CITY OF SARATOGA SPRINGS
DESIGN REVIEW COMMISSION

Design Review Commission Meeting – Wednesday, November 16, 2016

A. 2016.075 Obstarczyk Garage Demolition

147 Spring Street, Advisory Opinion to ZBA on the demolition of a contributing structure and reconstruction of a garage within the Urban Residential-3 District.

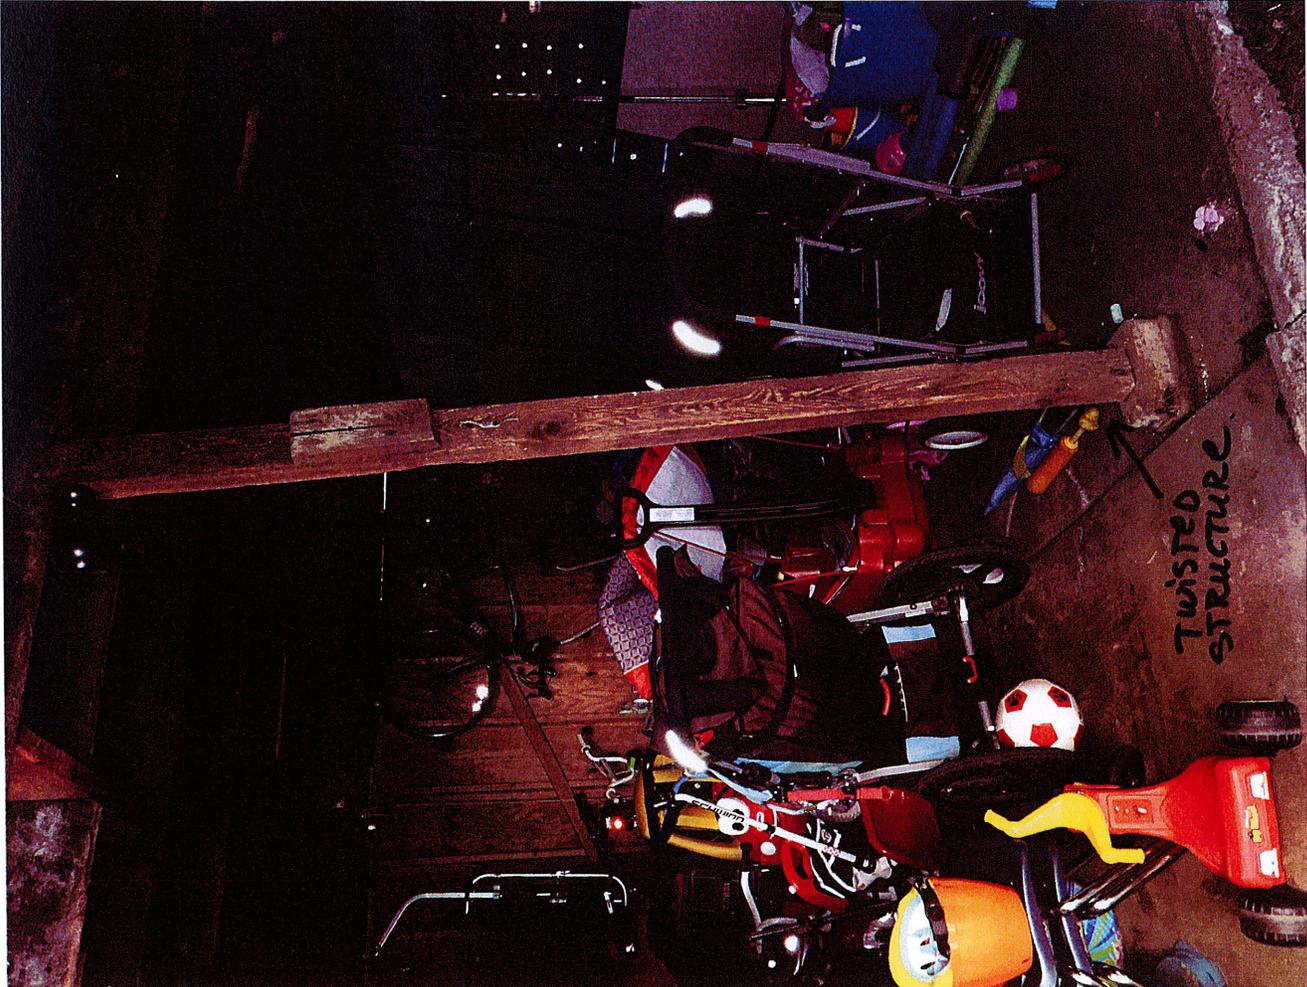
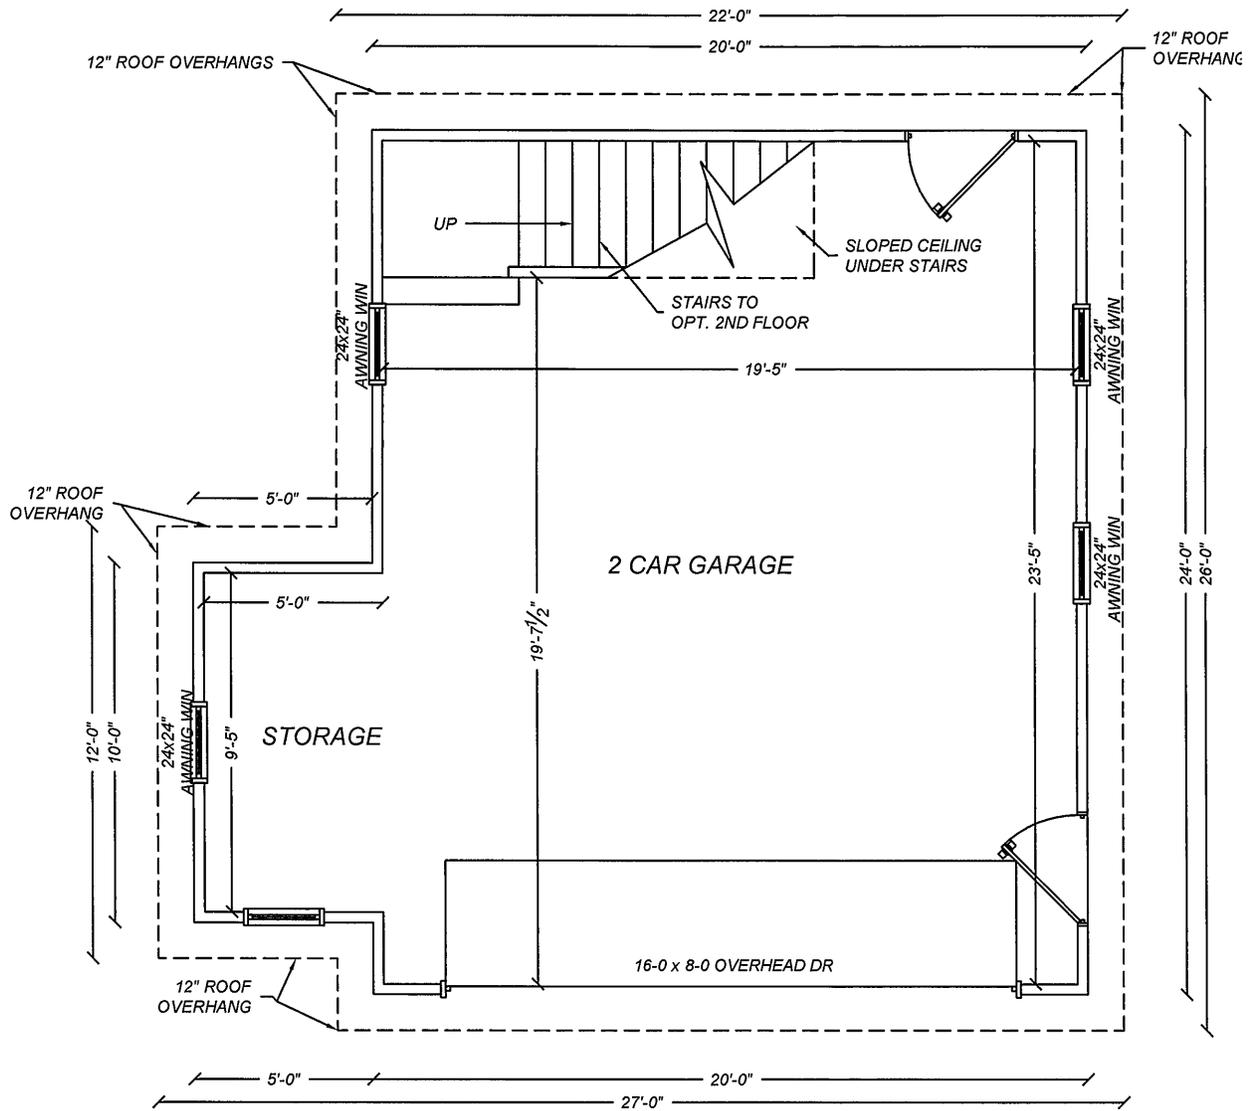
← LACK OF SILL PLATE AT WALL

TWISTED STRUCTURE

CORNER OF STRUCTURE
of STRUCTURE
skewed

THIS PORTION
of wall
framed straight

THIS PORTION
of wall skewed
TO MATCH TWISTED
STRUCTURE
